Permit Resubmittal Narrative – City of Miami Beach

1698 Alton Road FPL Vault / 219420456

Re: Secondary Plan Review Comments

Project No. 219420456
Scale N.T.S.
Revision 1
Drawing No. TE-101

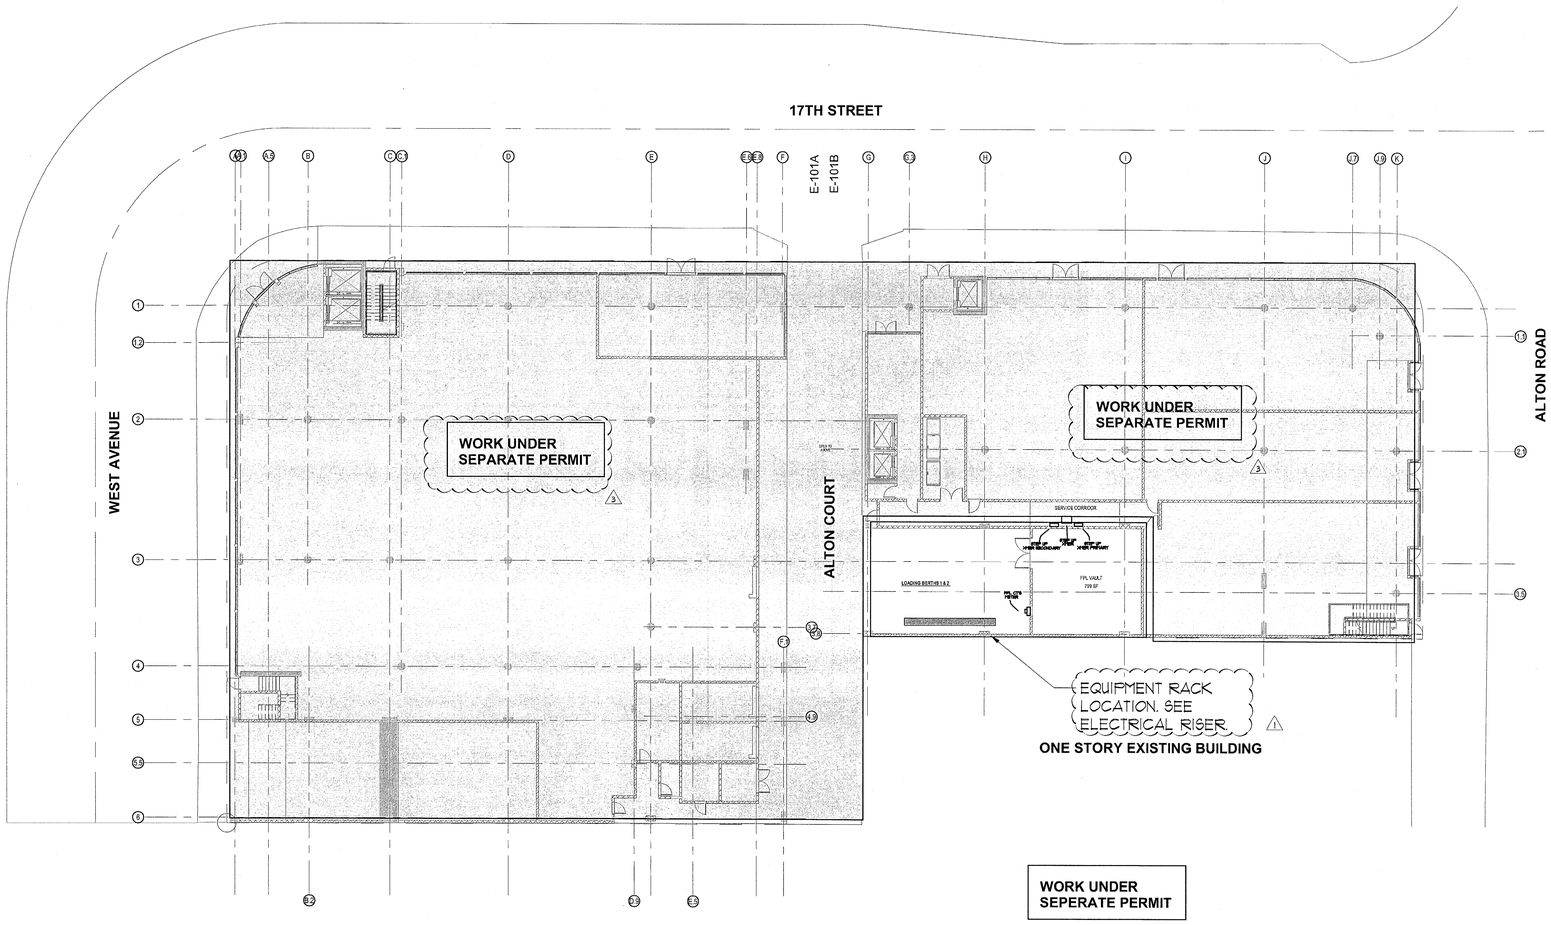
SAME COMMENT: 1- Revise Flood Information on sheet TE-101, this property is located on Flood Zone: "AE", Base Flood Elevation: +8.00' NGVD.

RESPONSE: Flood information has been revised. See updated sheet TE-101.

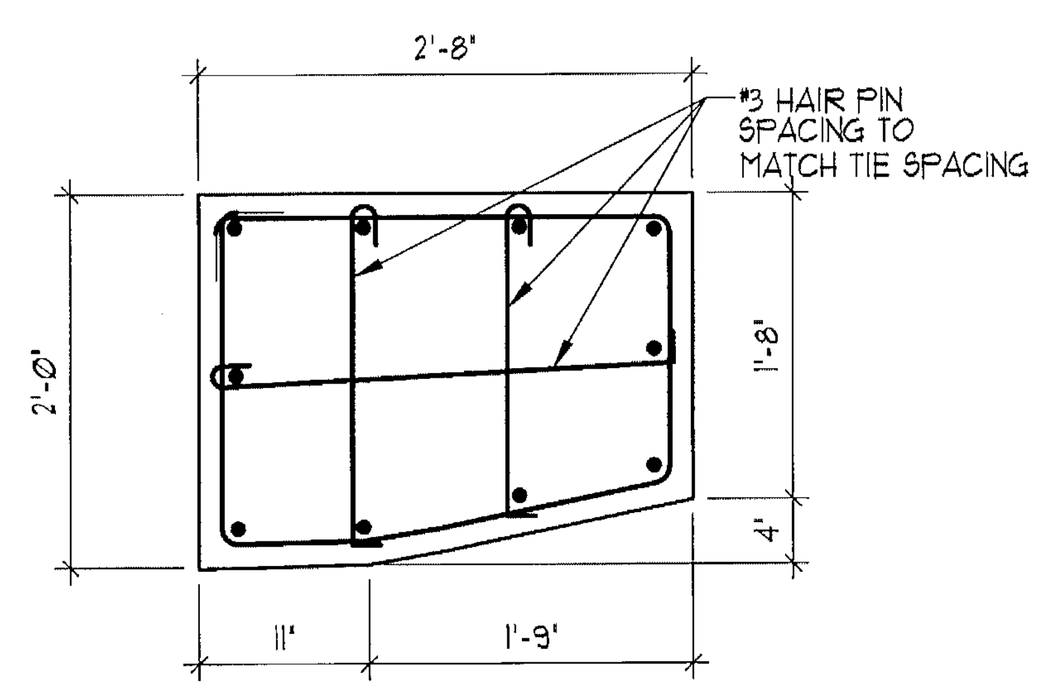
4.2) Provide size and reinforcement for column TC-1 (see plans on S-1.2).

RESPONSE: The TC-1 is in the tie column schedule on S-3.1.
